**Nebraska Public Power District**

NLS2017095  
November 30, 2017

**Subject:** Response to Nuclear Regulatory Commission Request for Additional Information  
for Relief Request RI-21, Revision 1  
Cooper Nuclear Station, Docket No. 50-298, DPR-46

**Response to Nuclear Regulatory Commission Request for Additional Information  
for Relief Request RI-21, Revision 1**

Figure 1

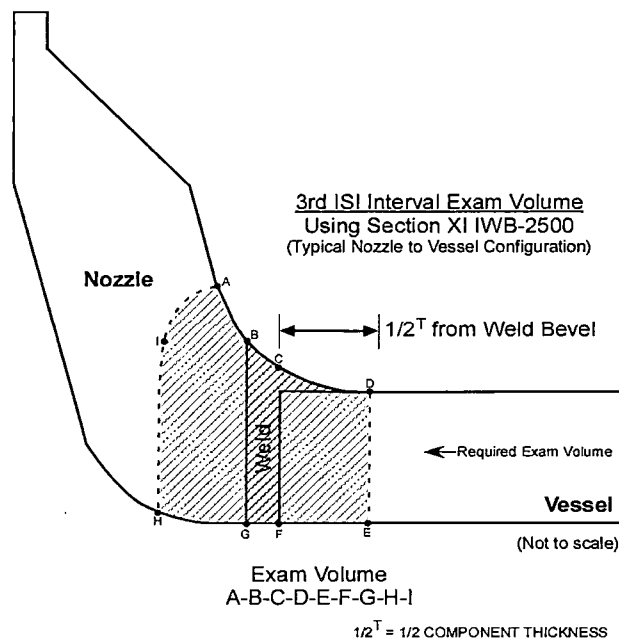
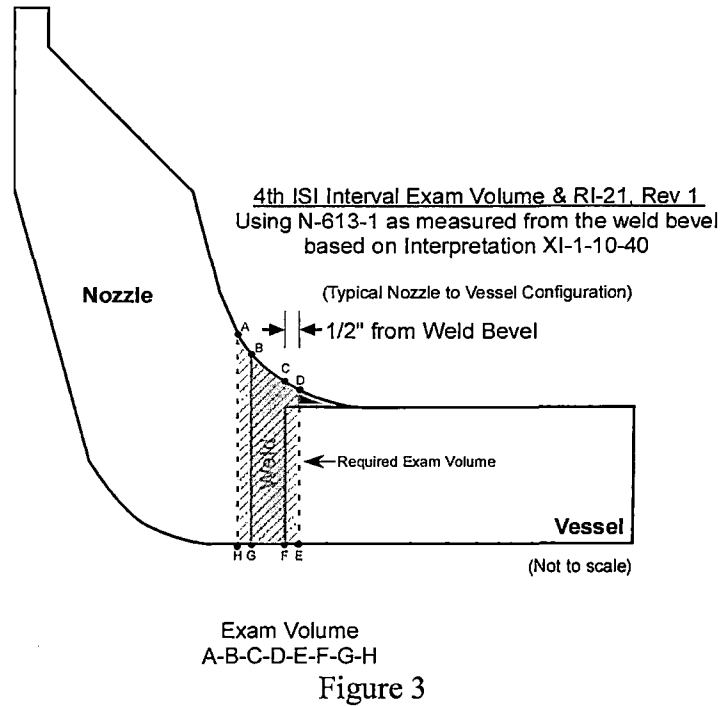
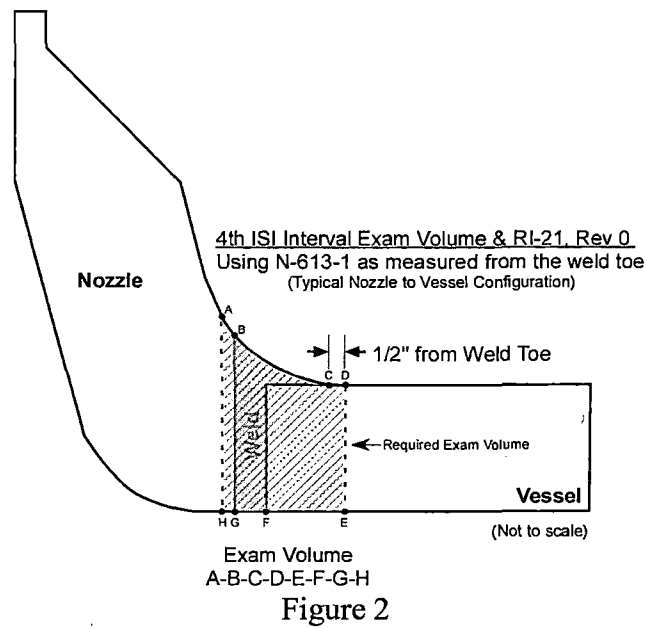
For several of the RPV nozzle welds addressed in RI-21, Rev. 1, the licensee reported limited scope examination coverages that had decreased from those that were previously approved by the NRC for an earlier version of this fourth ISI interval relief request. Specifically, in its safety evaluation dated January 12, 2010 (ADAMS Accession No. ML093521350), for Relief Request No. RI-21, Rev. 0, dated February 16, 2009 (ADAMS Accession No. ML090540420), the NRC staff granted relief for limited-scope examinations for several of the RPV nozzle welds that are now addressed again in RI-21, Rev. 1, with lower reported coverages. The limited scope exams that were previously approved for the fourth ISI interval are identified in Table 1 below.

- a. For those RPV nozzle weld exam limitations that were previously approved per RI-21, Rev. 0, please state whether the actual UT that achieved the limited coverages reported in RI-21, Rev. 1 are the same as those previously addressed in RI-21, Rev. 0. Specifically, were the new reduced examination coverages addressed in RI-21, Rev. 1 determined exclusively by recalculation?

- b. If the changes to the RPV nozzle weld limited coverages from RI-21, Rev. 0 to RI-21, Rev. 1 were determined exclusively by recalculation, please explain whether the recalculated limited examination coverages for RI-21, Rev.1 were based on:

- (1) Changes to the definition of the full scope (i.e., 100 percent) exam volume, as specified in Figure IWB-2500-7 of the Code vs. ASME Code Case N-613-1; or

- (2) changes to the methodology used for crediting and/or determining the achieved coverage;  
or
  - (3) a combination of (1) and (2).

For example, Section 2.0 of Appendix 1 of the attachment to RI-21, Rev. 1 reports "25.76" percent as the limited scope examination coverage of RPV Nozzle Weld NVE-BD-N1A, which is a reduction from the previously approved RI-21, Rev. 0 coverage of "46" percent. However, it is not clear whether the 25.76 percent limited-scope coverage in Rev. 1 is based on the full scope (100 percent) exam volume specified Figure IWB-2500-7 (i.e., Exam Volume "A-B-C-D-E-F-G-H-I") of Table IWB-2500-1 of the ASME Code, Section XI or the alternative reduced examination volume specified in ASME Code Case N-613-1, Figure 1 (i.e., Exam Volume "A-B-C-D-E-F-G-H"), and/or whether there was a change in methodology for crediting actual

*coverage. Please clarify this issue for all limited RPV nozzle weld exams that were previously approved in RI-21, Rev. 0 so that the NRC staff can accurately determine the basis for the changes in limited coverages addressed RI-21, Rev. 1.*

- c. The NRC staff identified that relief was not previously requested or approved in RI-21, Rev. 0 for the reactor feedwater nozzles, top head spray nozzle, top head vent nozzle, CRD return line nozzle, and several of the recirculation inlet nozzles. For these nozzle weld exams, please explain how the application of Code Case N-613-1 for the fourth ISI interval would result in lower exam coverages than those reported for the third ISI interval, given that the full scope (100 percent) exam volume per the Code Case is lower than that required by Figure IWB-2500-7 of the Code. The response to this part should also address any other reasons for a reduction in examination coverage from third to fourth ISI interval not related to Code Case N-613-1 (e.g., such as corrective action for crediting excessive exam coverage, similar to issues raised in RAI-5).*

- a. The examination coverages of the nozzles listed in RI-21, Revision 0, were recalculated based on the original UT examinations conducted early in the Fourth Interval. The recalculated values were included in RI-21, Revision 1, along with the other nozzles that were examined later in the interval.

- b. Due to questions regarding the definition of the full scope (100 percent) volume specified in Figure IWB-2500-7(a) as well as the alternative reduced examination specified in Figure 1 of ASME Code Case N-613-1, CNS requested ASME Section XI clarify the examination volume requirements for the CNS nozzles since the nozzle-to-shell blend radius weld extended well beyond the weld bevel. ASME responded with Interpretation XI-1-10-40 that clarified the examination volume in ASME Section XI and Code Case Figures, i.e., A-B-C-D-E-F-G-H-I in Figure IWB-2500-7(a) and A-B-C-D-E-F-G-H in Figure 1, respectively, is determined from the weld bevel vs. the toe of the nozzle-to-shell blend radius weld as previously calculated. It should also be noted that there was a typographical error in RI-21, Revision 1, where Note 1 for nozzles N1A (page 12), N2 (page 18), N3 (page 23), and N5 (page 40) made reference to 1/2T which should have been 1/2 inch.

Changes in the way CNS applied the definition of the alternative reduced volume in N-613-1 is the basis for the changes in coverages from RI-21, Revision 0, to RI-21, Revision 1. Additional nozzles that were added with Revision 1 because they were examined later in the

Interval were calculated from the alternative reduced volume based on the clarification of the ASME Interpretation. Figures 1, 2, and 3 identify how the examination volume was applied to the CNS nozzles. Figure 1 identifies how the volume was defined in the Third Interval ( $T/2$  beyond weld bevel, nozzle and vessel sides). Figure 2 identifies how the volume was defined for the nozzles listed in RI-21, Rev. 0 ( $1/2$  inch beyond the weld toe of the blend-radius on the vessel side,  $1/2$  inch beyond the bevel on the nozzle side). Figure 3 identifies how the examination volume was defined for all the nozzles examined in the Fourth Interval ( $1/2$  inch beyond weld bevel, both sides) after clarification per Interpretation XI-1-10-40. The reduction of the vessel side exam volume from  $1/2$  inch beyond the weld toe of the blend-radius on the vessel side (Revision 0, Figure 2) to  $1/2$  inch from the weld bevel (Revision 1, Figure 3) attributed to an 18 to 22 percent loss in total reported coverage on the applicable welds previously stated in RI-21, Revision 0. The methodology used for determining and crediting the examination coverages was not changed between the two versions of the Relief Request.

- c. The differences between the Third and Fourth Interval coverages are due to the change in the way CNS defined the examination volume in the Third Interval (Figure 1) compared to the Fourth Interval (Figure 3). Figure 1 shows the Third Interval examination volume vs. Figure 3 that shows the Fourth Interval examination volume associated with the reactor feedwater nozzles, top head spray nozzle, CRD return nozzle, and several recirculation inlet nozzles. The top head vent nozzle is a slightly different configuration that resulted in a slight increase of coverage from the Third to Fourth Interval (i.e., 58.6% to 59.09%).
- d. The first sentence in Note 1 was a "copy and paste" error carried over from the RHR-CA-2A note section and therefore is not applicable to NVE-BD-N7. The achieved examination coverage for this weld in the Third Interval was 58.6% in RE18 (1998).
